HISTORIC AND DESIGN REVIEW COMMISSION

HDRC CASE NO: 2019-004
ADDRESS: 2310 ROOSEVELT AVE
LEGAL DESCRIPTION: NCB 7456 BLK LOT 11 (D FAULKNER)
ZONING: I-1, H, RIO-5
CITY COUNCIL DIST.: 3
DISTRICT: Mission Historic District
APPLICANT: Dathan Faulkner/Allstate Gear
OWNER: Dathan Faulkner/Allstate Gear
TYPE OF WORK: Construction of a storage structure
APPLICATION RECEIVED: January 02, 2019
60-DAY REVIEW: March 03, 2019
REQUEST:

The applicant is requesting a Certificate of Appropriateness for approval to construct a storage structure at the rear of the site to feature a footprint of approximately 12,000 square feet.

WALL ELEVATION AT GRID E

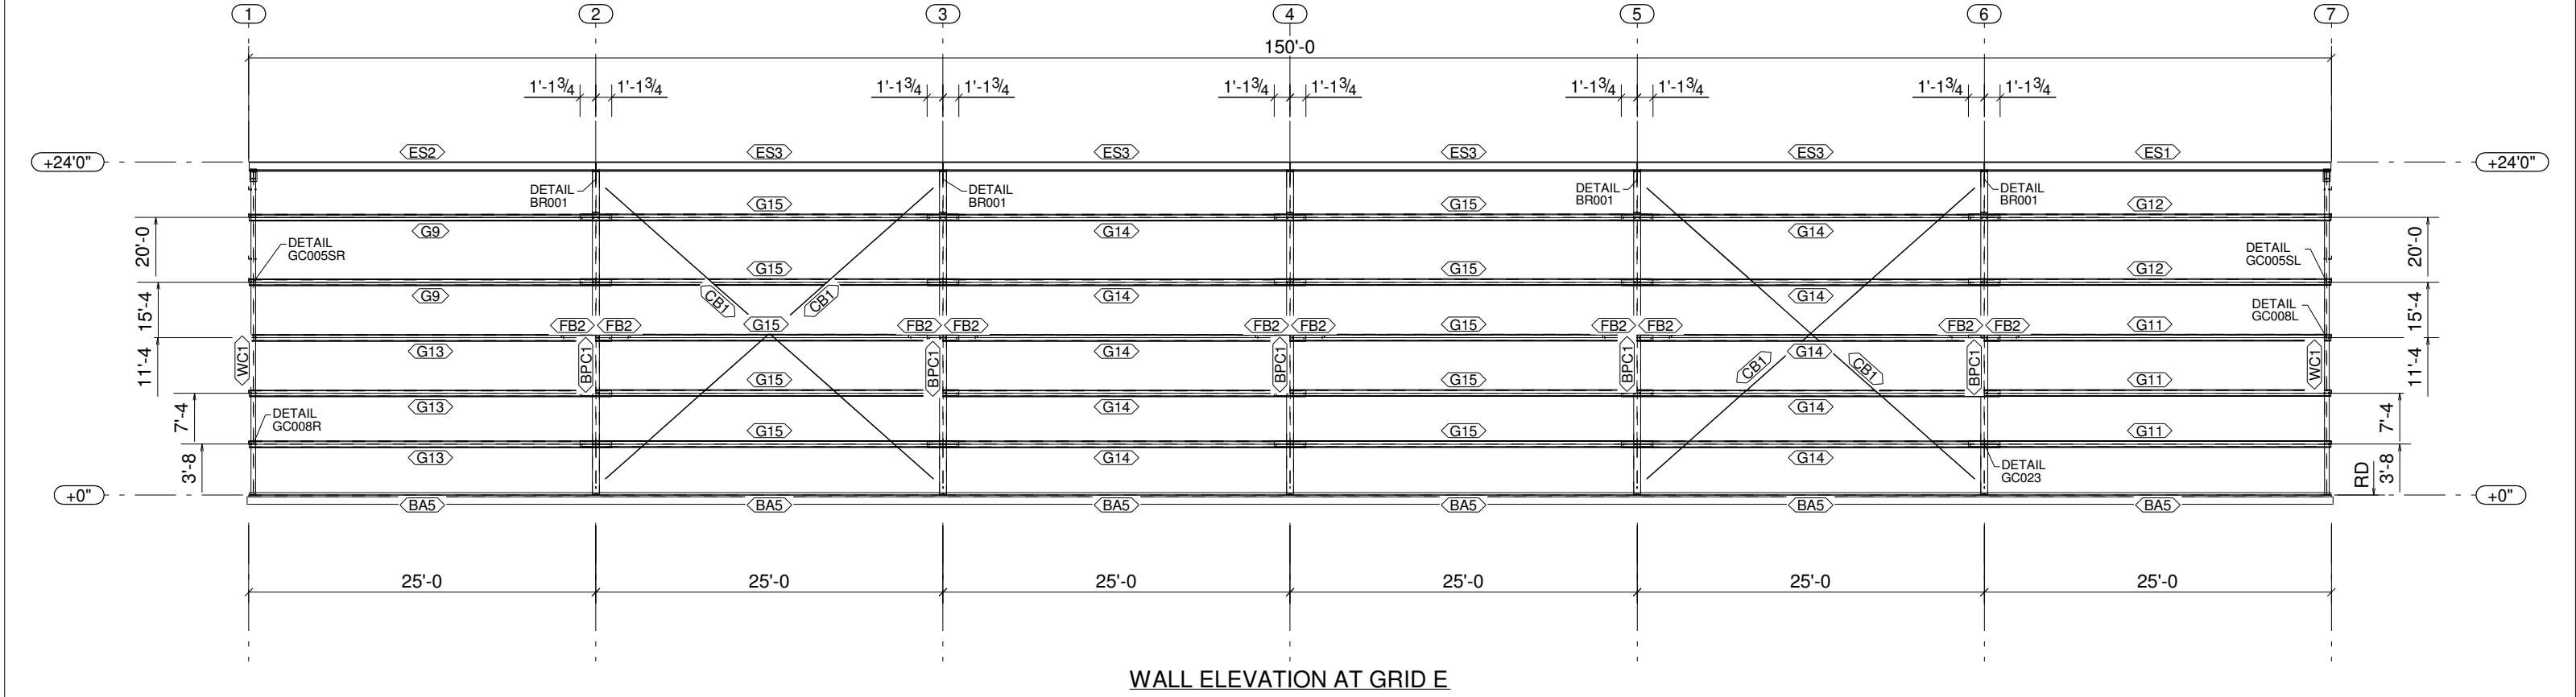
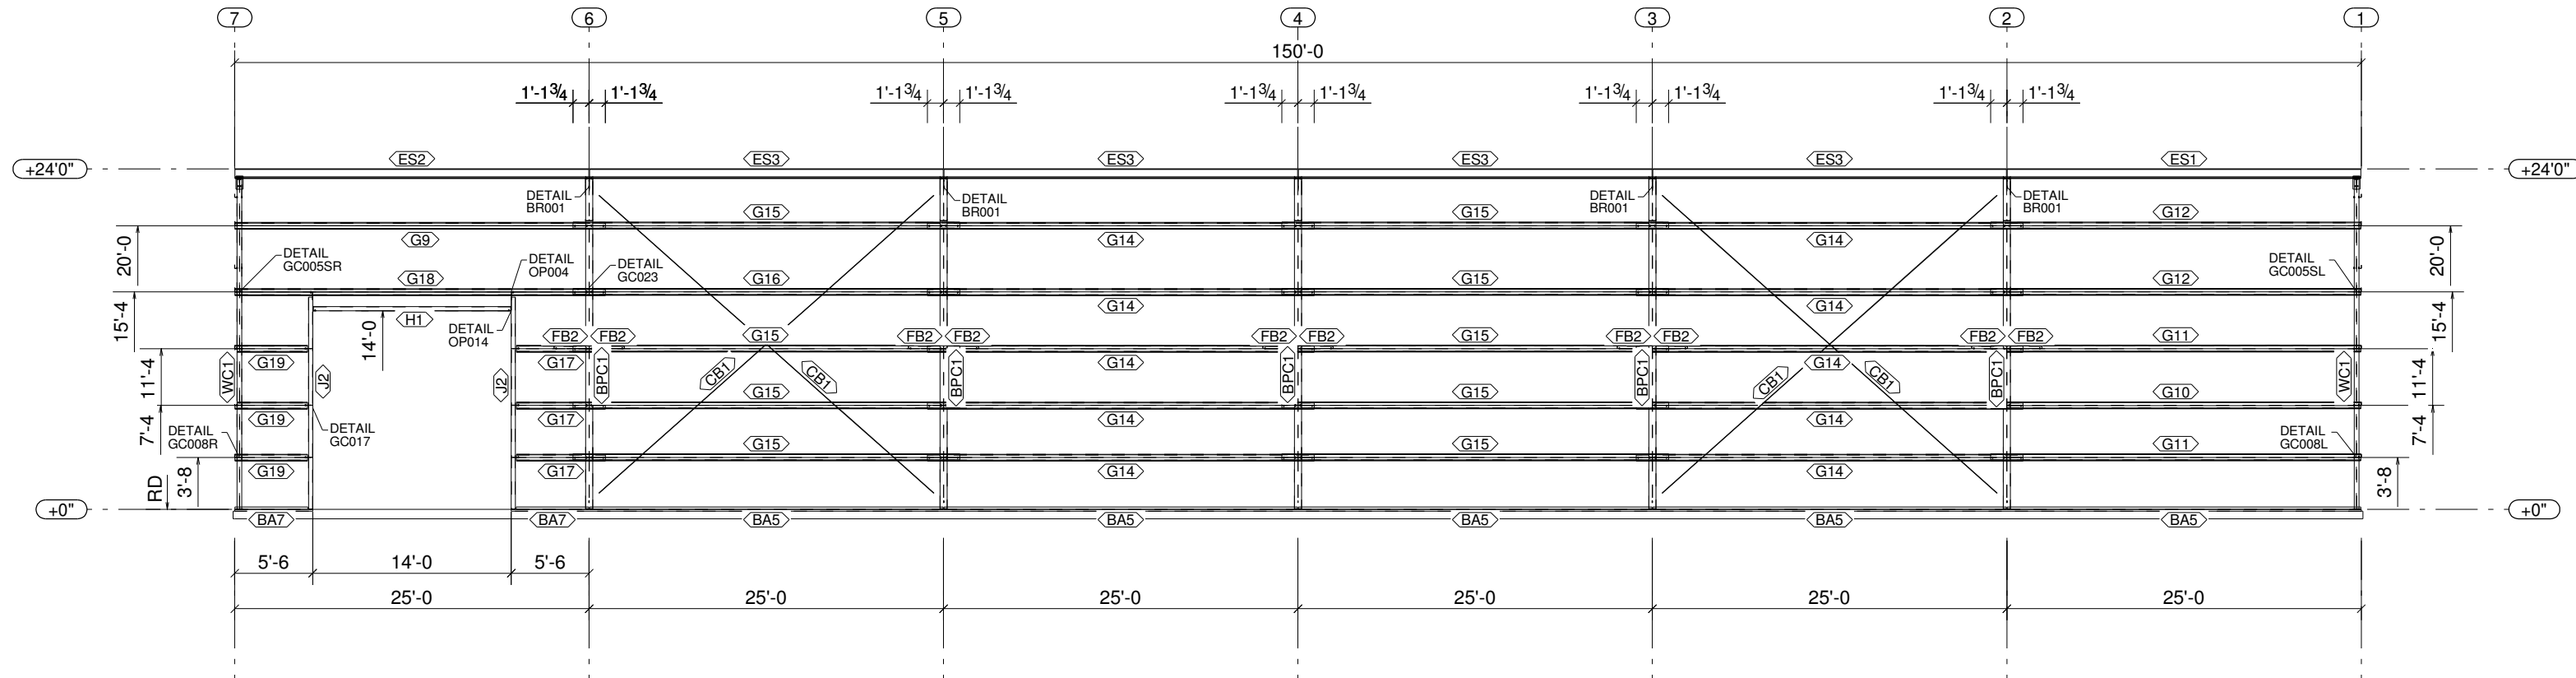
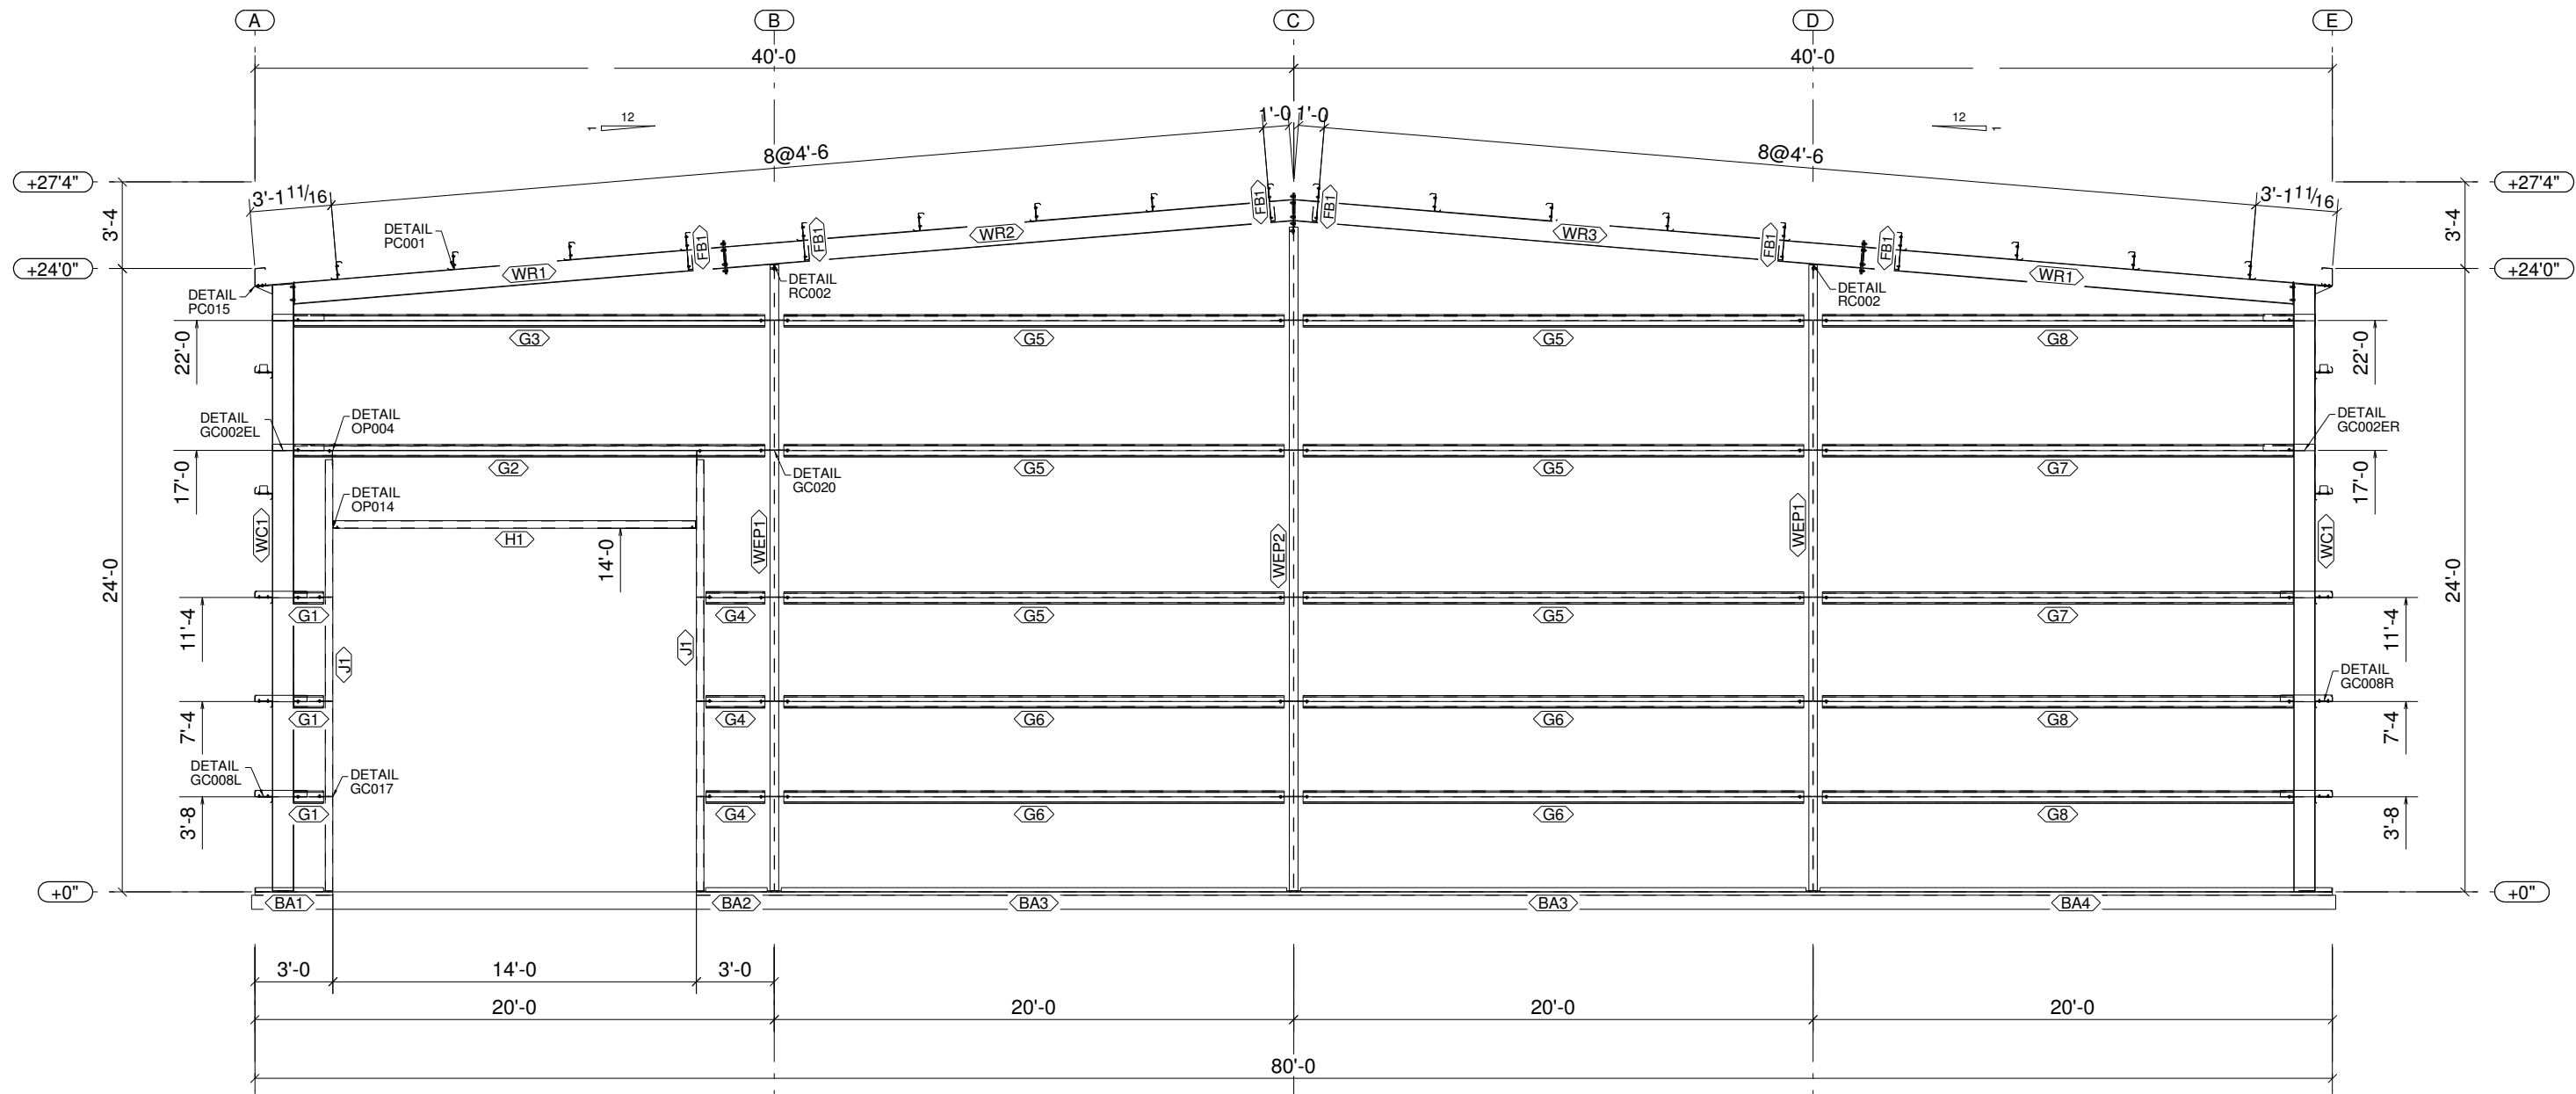
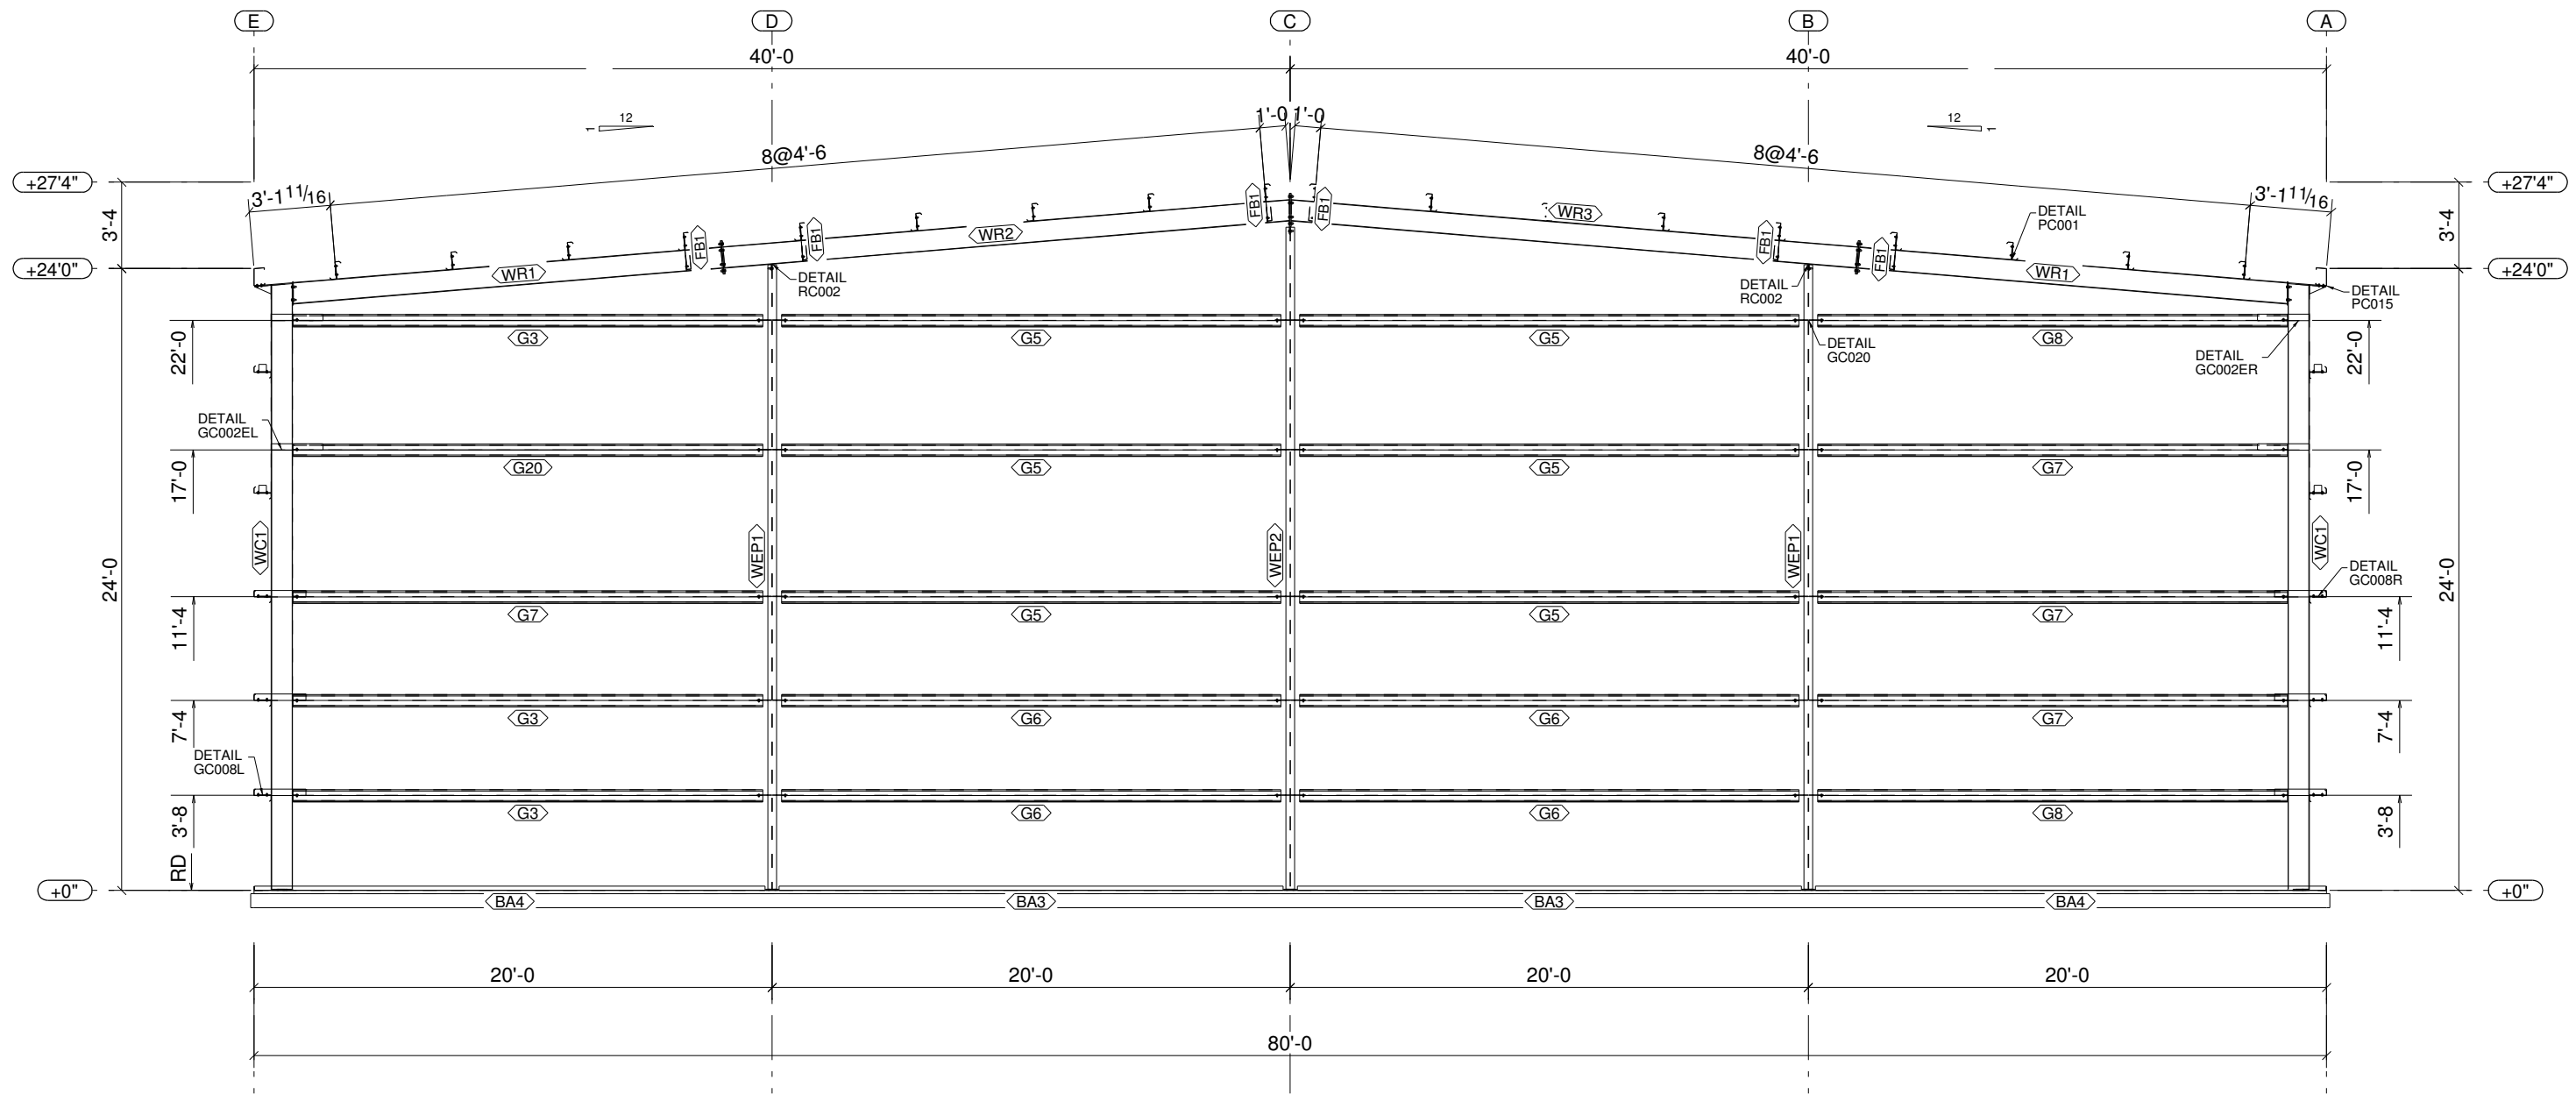
- e. FAÇADE SEPARATION – The Mission Design Manual notes that structures within the Mission Historic District should not feature façade planes that are greater than fifty (50) feet in width. The applicant has proposed façade panels that are twenty-five (25) feet in width each.

- g. MATERIALS – The applicant has proposed for the structure to feature a steel structure and metal siding. The proposed materials are consistent with those existing on site.

- i. That the applicant explore the use of masonry as a primary or secondary material on portions of the proposed storage structure.
